Summary of Revised Materials

Brickhaven No. 2 Mine Tract A - Mine Permit Transfer/Modification Application

Addendum 1 - March 13, 2015

Mine Permit Transfer/Modification

SHEET
02C-01

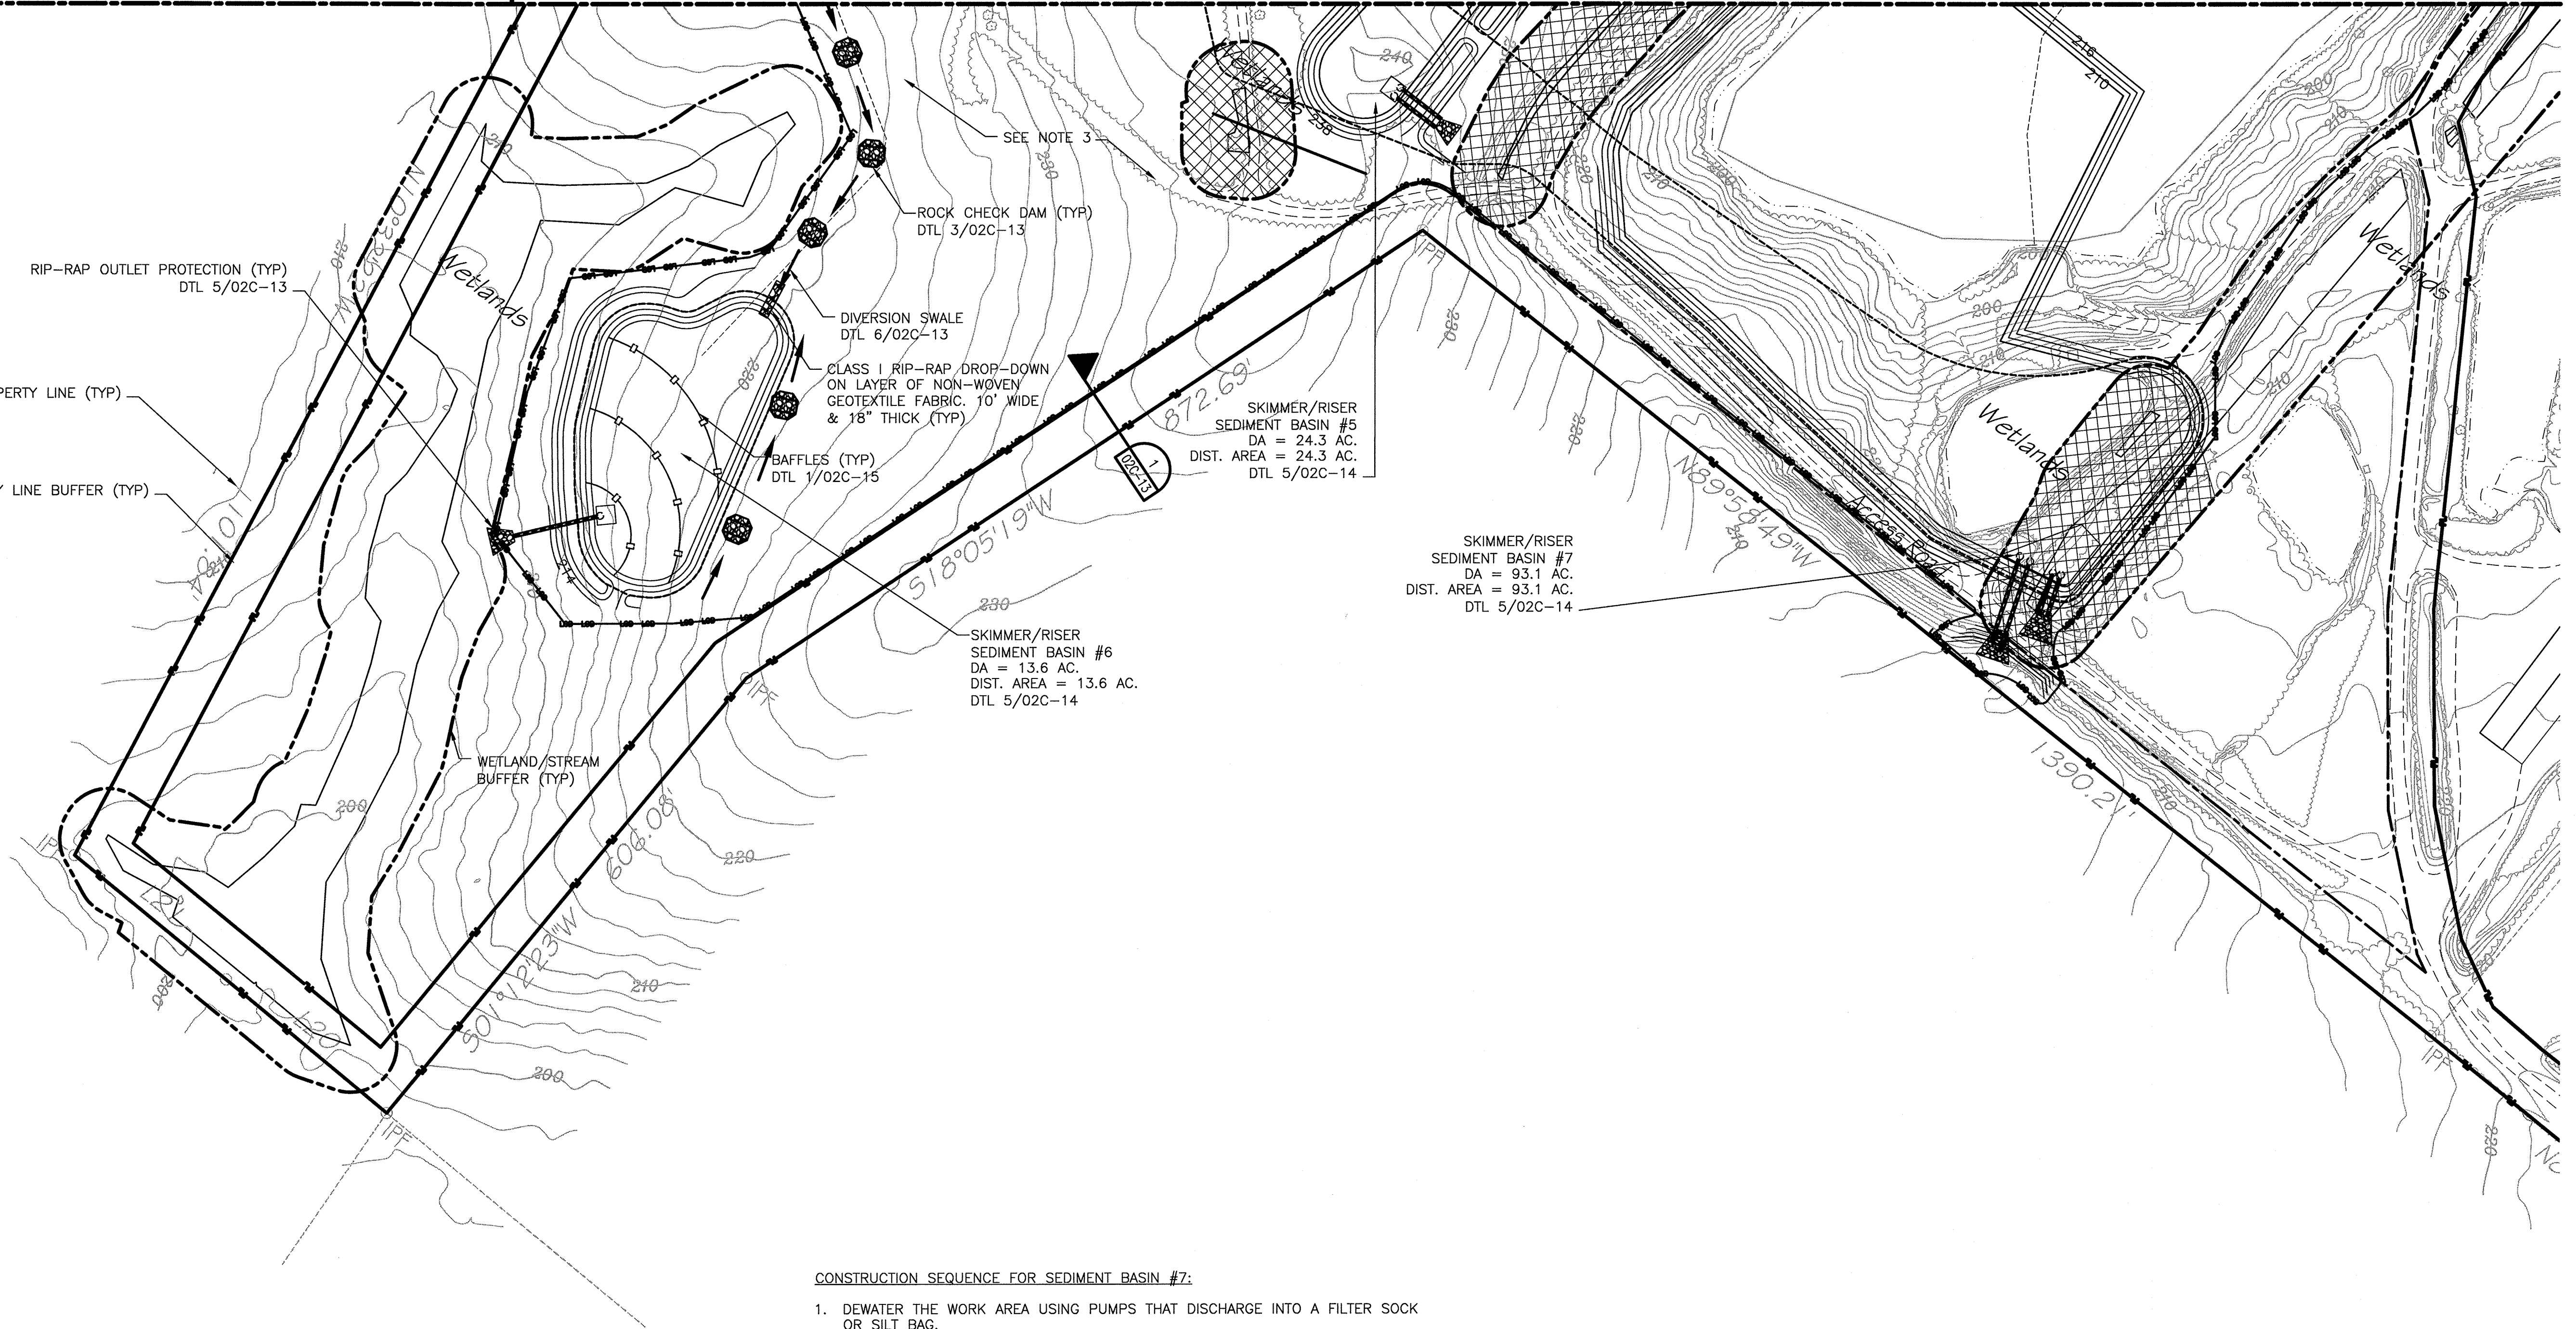
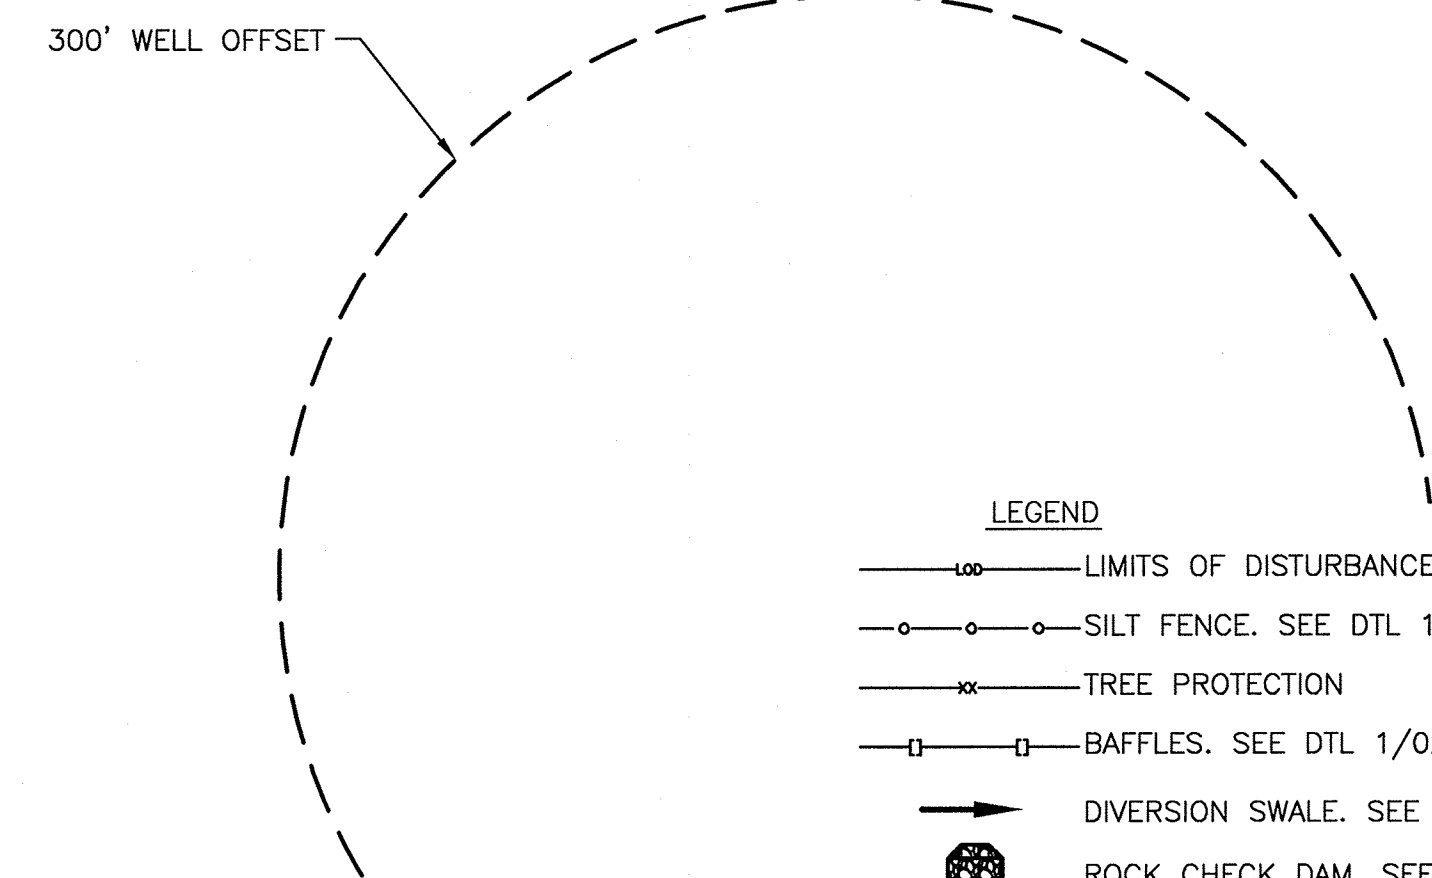
ISSUE	DATE	DESCRIPTION
C	03/2015	RESIZED BASIN #7
B	12/31/14	REVISED PER NCDENR COMMENTS
A	11/2014	ISSUED FOR APPROVAL

SHEET
02C-07

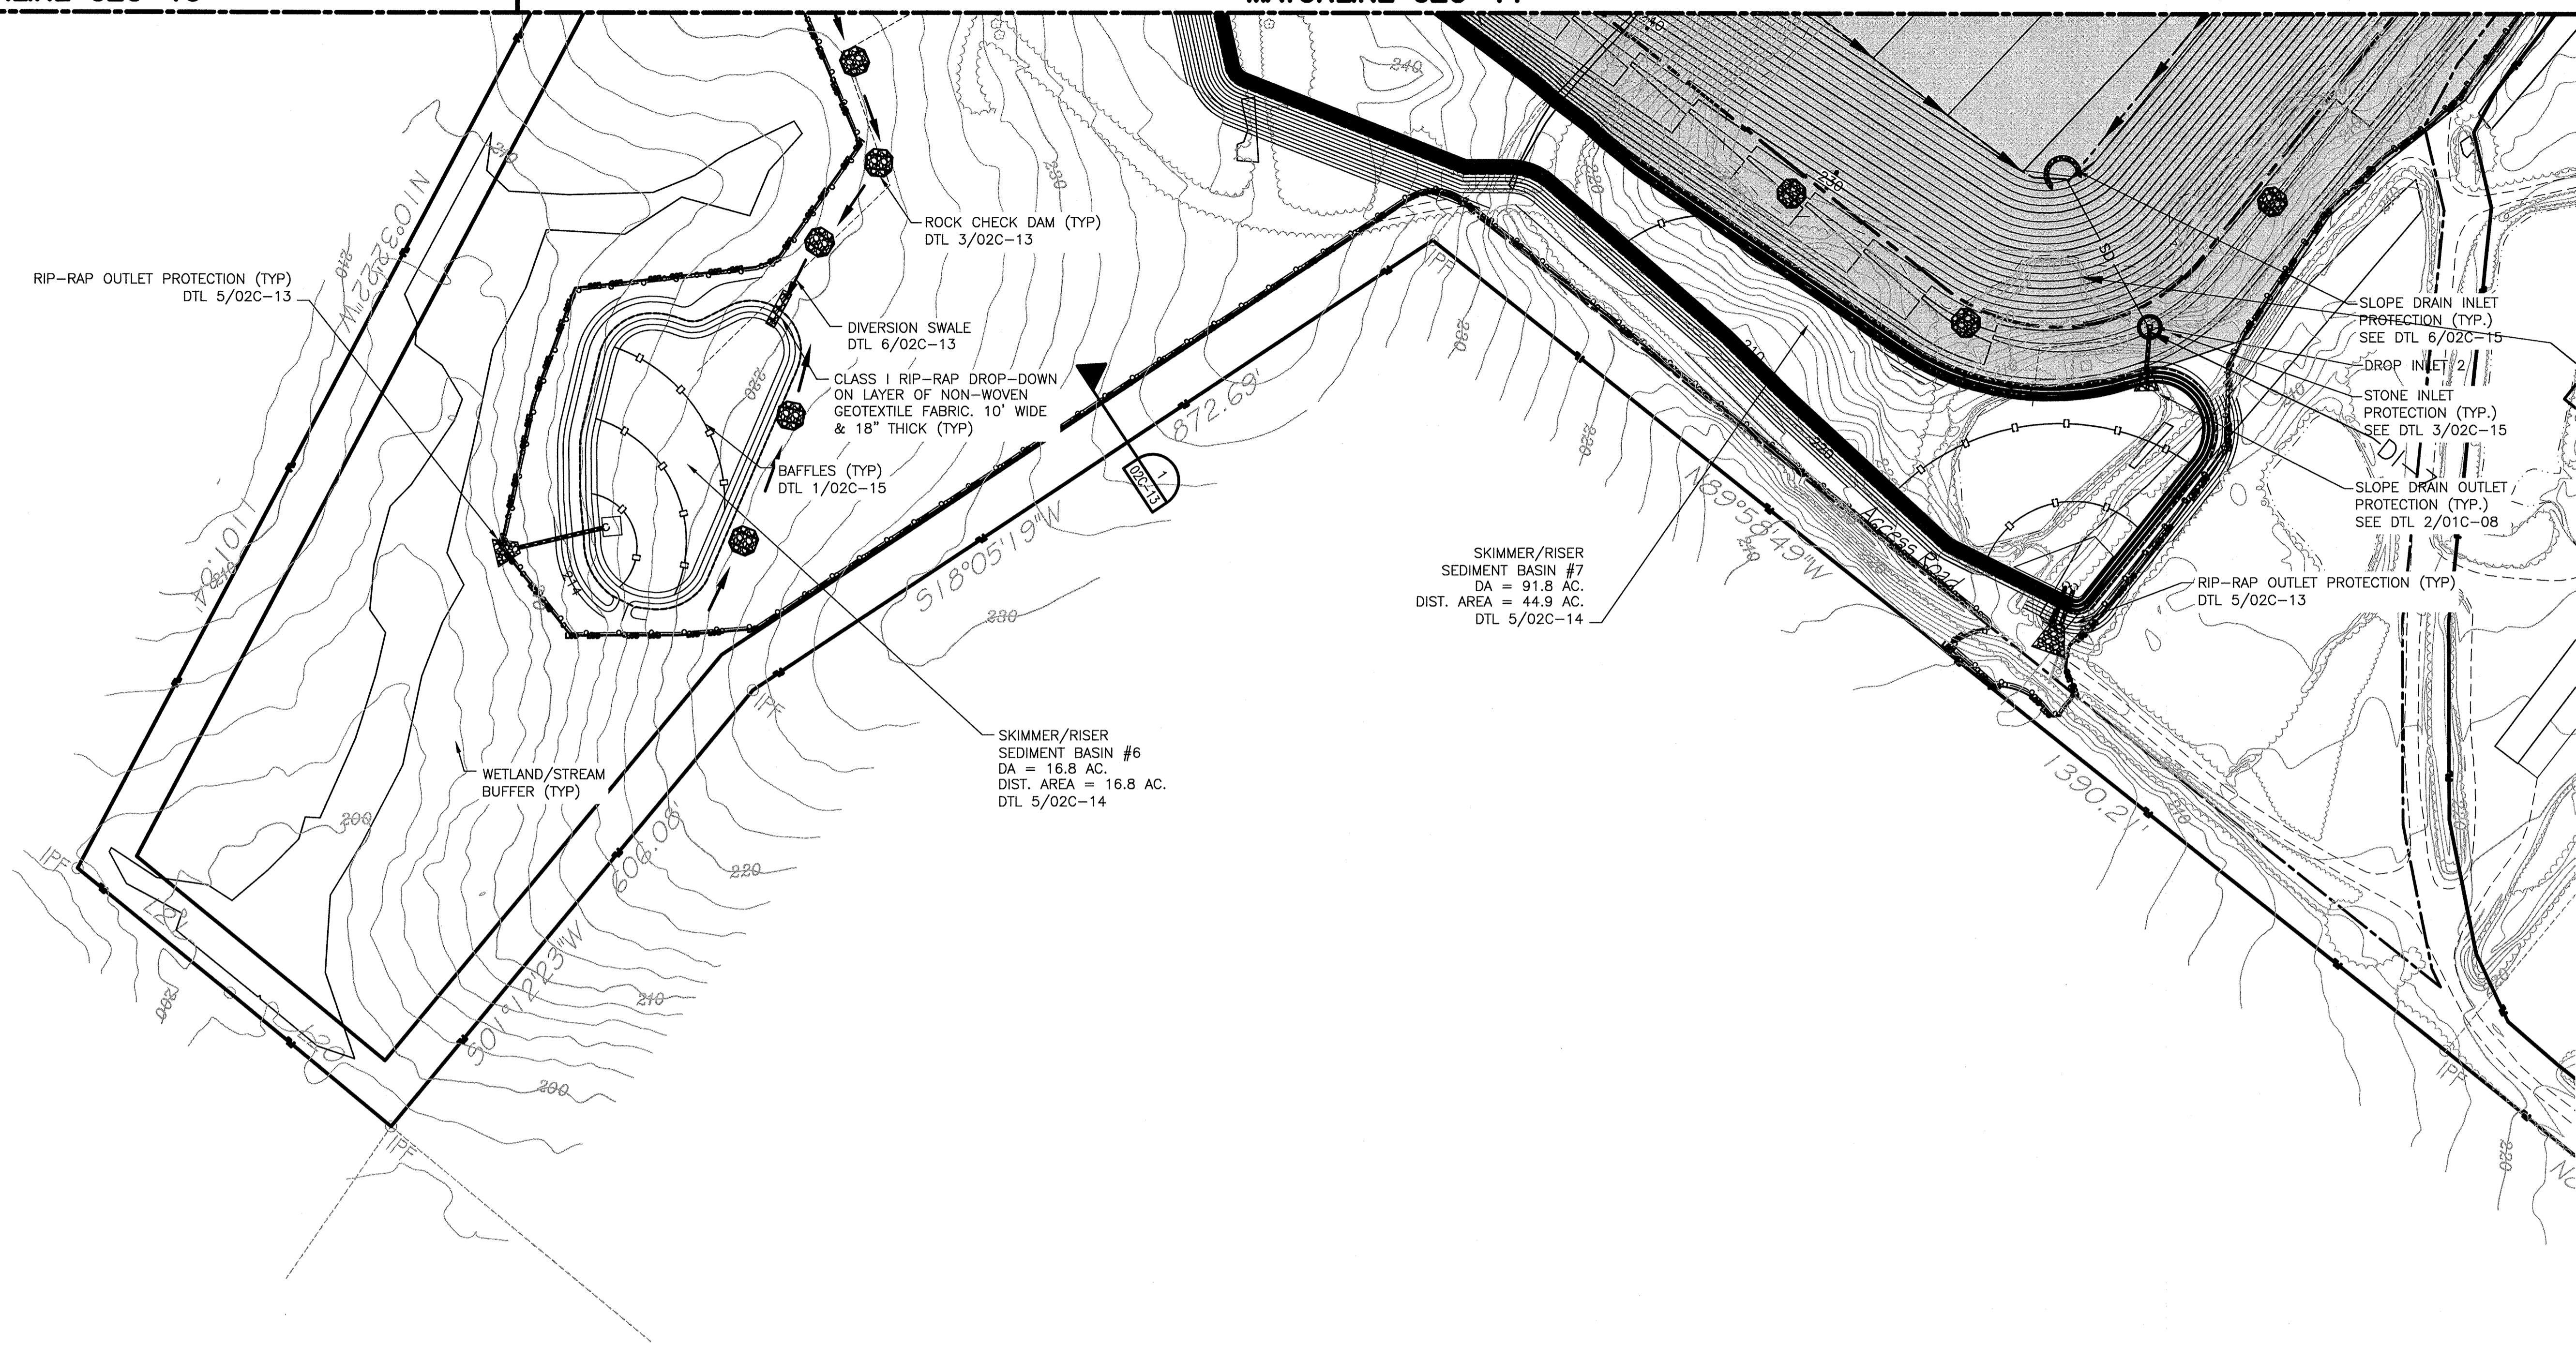
Section / Item	Action Needed	Comments
Binder		
Cover	replace	added revision date
Spine	replace	added revision date
Calculation B Stormwater		
Sediment Basin #5 Sediment Basin #7	Replace select sections	Revisions to Sediment Basins 5 and 7 for 25-year 24-hour storm
Drawings		
02C-01 02C-06 02C-07 02C-12 02C-13 02C-14	replace select drawings	Revisions to Erosion & Sediment Control Plan for 25-year 24-hour storm

**EROSION AND SEDIMENTATION
CONTROL PLAN - PHASE 2
PLAN 5**

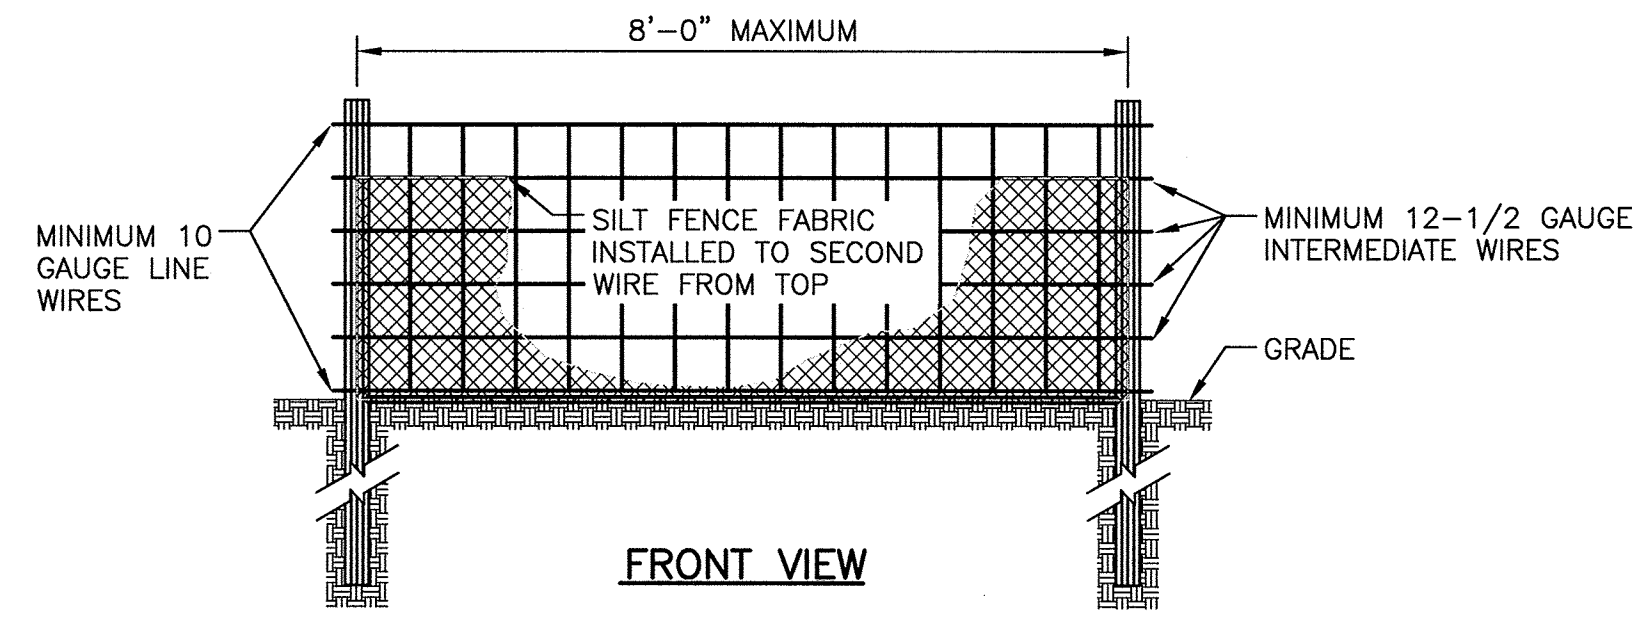
ISSUE	DATE	DESCRIPTION	PROJECT NUMBER
C	03/2015	RESIZED BASIN #7	453925-237673-018
B	12/31/14	REVISED PER NCDENR COMMENTS	
A	11/2014	ISSUED FOR APPROVAL

RIPRAP APRON AT PIPE OUTFALLS

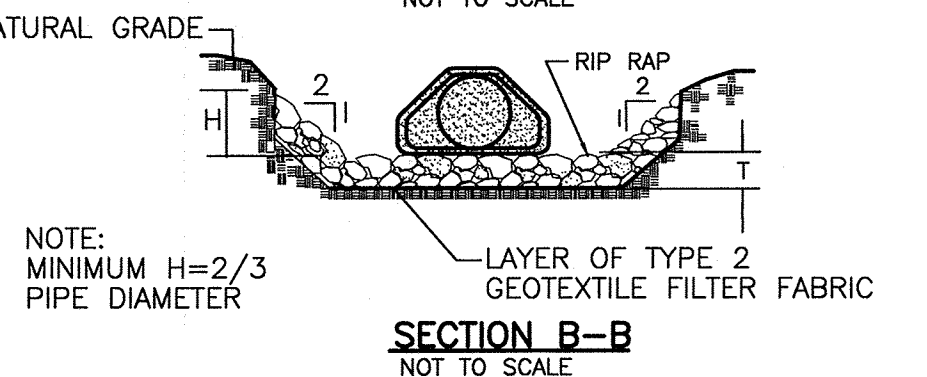
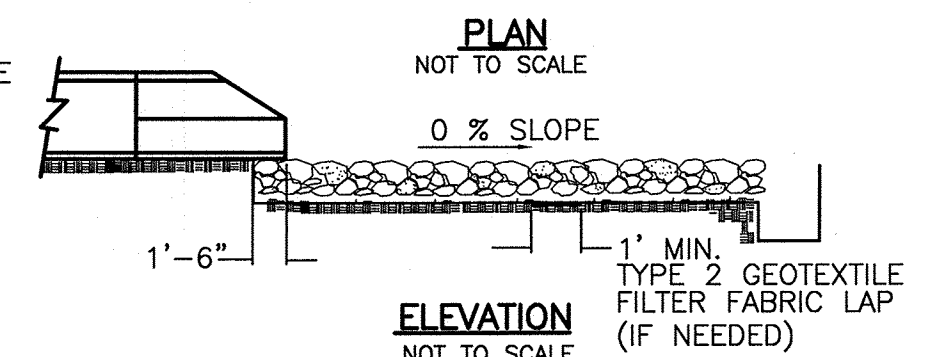
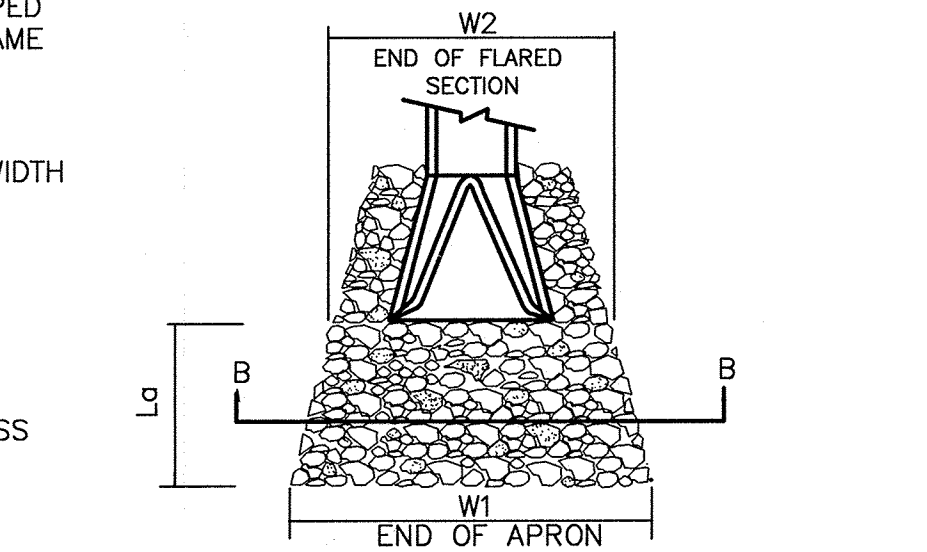
ISSUE	DATE	DESCRIPTION
C	03/2015	REVISED RIPRAP APRON SCHEDULE
B	12/31/14	REVISED PER NCDENR COMMENTS
A	11/2014	ISSUED FOR APPROVAL

- SB = SEDIMENT BASIN
- CLASS = NCDOT CLASS RIP RAP
- * = FOR EACH BARREL. SEE SEDIMENT BASIN SCHEDULE ON 02C-14
- CLASS A RIP RAP MIDRANGE = 4"
- CLASS B RIP RAP MIDRANGE = 8"
- CLASS 1 RIP RAP MIDRANGE = 10"
- CLASS 2 RIP RAP MIDRANGE = 14"
